City of Richmond

Re: Request for Quotation 4215Q – Supply and Installation of Piles at Garry Point Park - Addendum Three (3)

GARRY POINT TALL SHIP FLOATS
 PILE ANODE DETAIL
 HEL PROJECT NO. 2167-003
 REV.2 RE-ISSUED FOR ADDENDUM
 MARCH 2, 2011

TYPICAL FOR ALL PILES
CATHODIC PROTECTION DETAIL
 N.T.S.

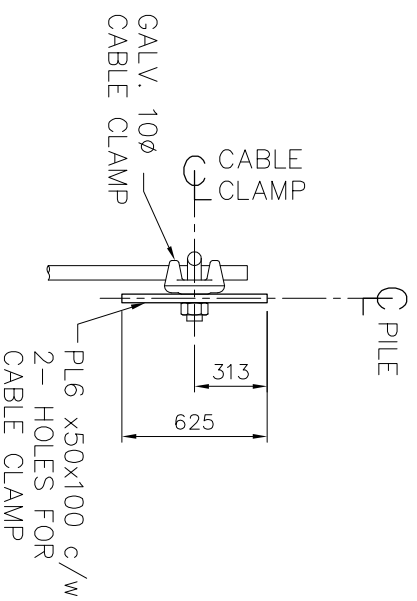
Please replace the following statement in A.1 of Addendum Two with the following:

The anodes are to be 36 lb zinc anodes. They are to be a hanging type of anode and either cylindrical or square bar shaped with a maximum width of three (3) inches and a length suitable to meet a weight of 36 lbs (the length will be agreed on by the Successful Bidder and the City prior to construction). The anodes shall be hung from the pile top with a steel cable allowing them to be inspected and/or changed out without the use of divers. The cable extends from the top connection to the anode. Please see the revised detail, appended to this Addendum.
